Memo to Mr. A. M. Tove Date March 28, 1960.
Bridge Engineer. Subject Re: W.P. 194-58 - Campbell
Materials & Research Section. Corners Side Road,
Hwy. 403 - District 4.

Memo to Mr. A. M. Toye, Date September 9, 1959.
Bridge Engineer. Subject FOUNDATION REPORT -
From Materials & Research Section. W.P. 194-58 -- W.J. F-59-71.

FOUNDATION REPORT

Proposed Hwy. #403 & Relocated Gravel Rd.
Between Lots 1 & 2, Approximately 2 Miles
N.E. of Aldershot, Twp. of Flamborough E.,
District #4.

F59-71A

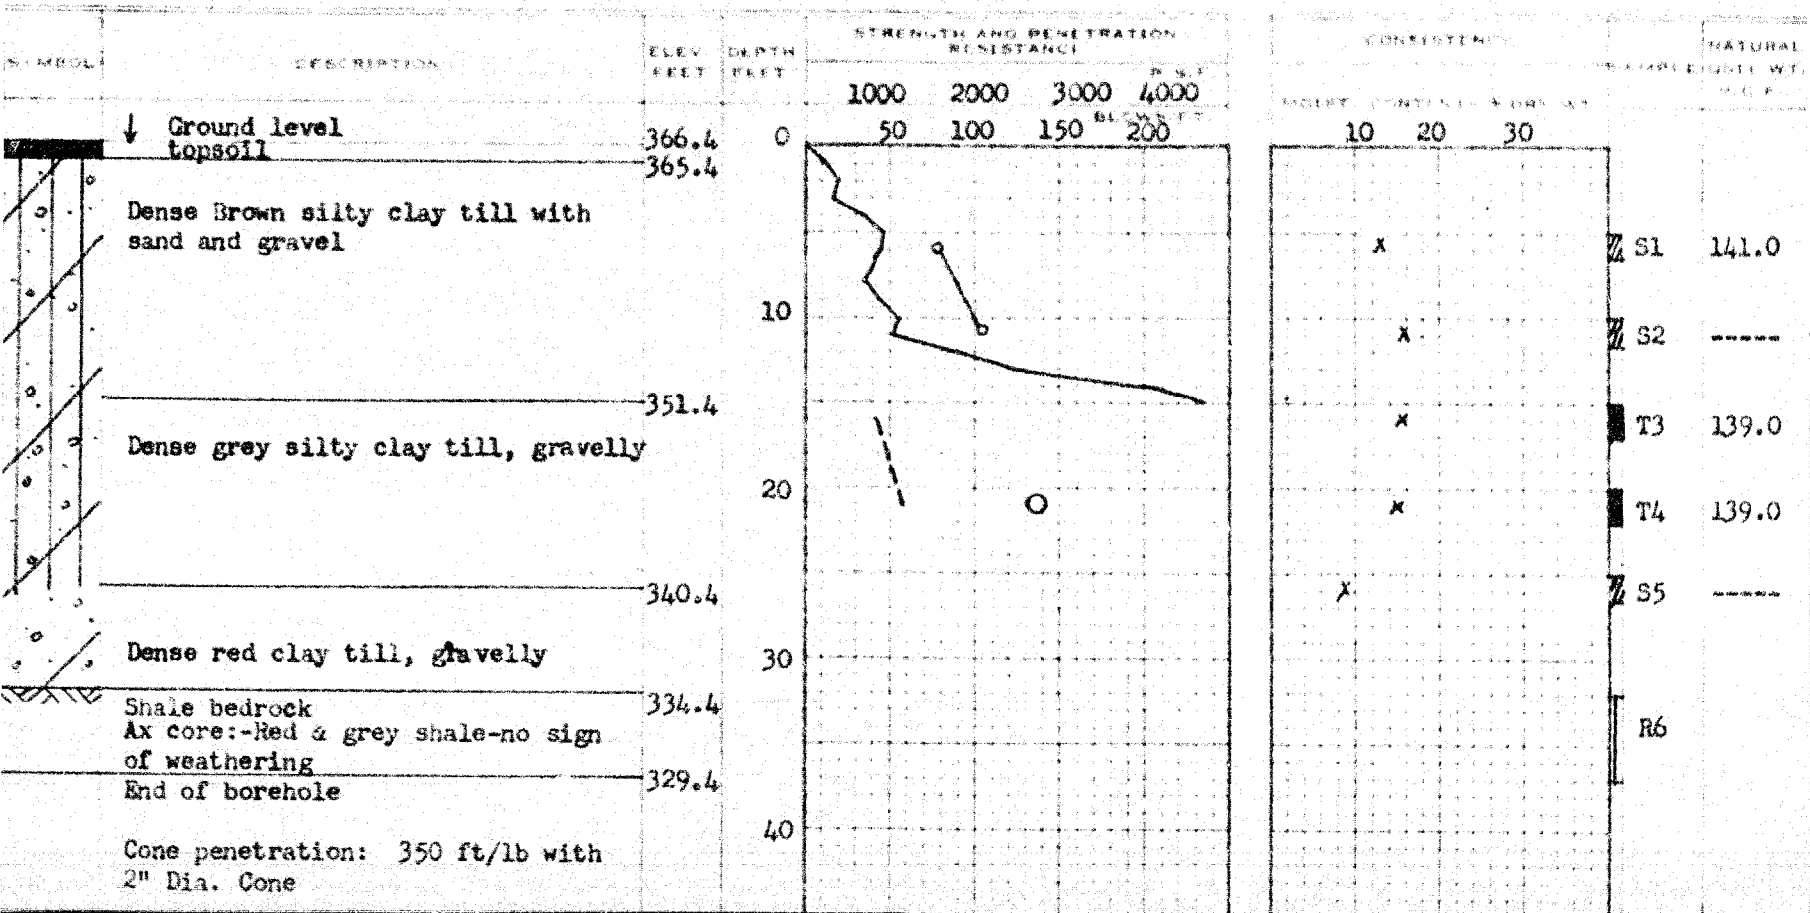
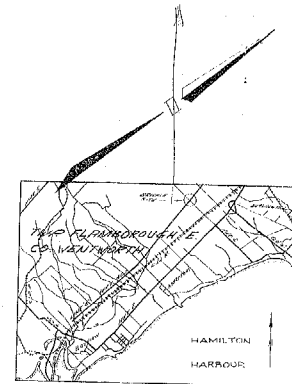
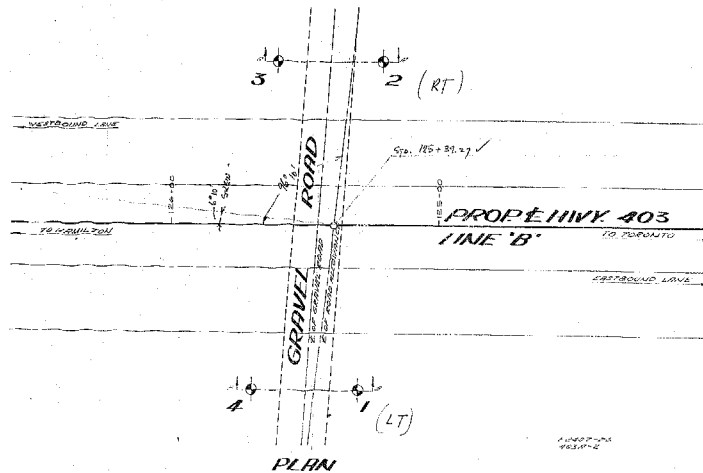
Drawing No. F 59-71A shows the borehole locations and the estimated subsoil stratigraphy.
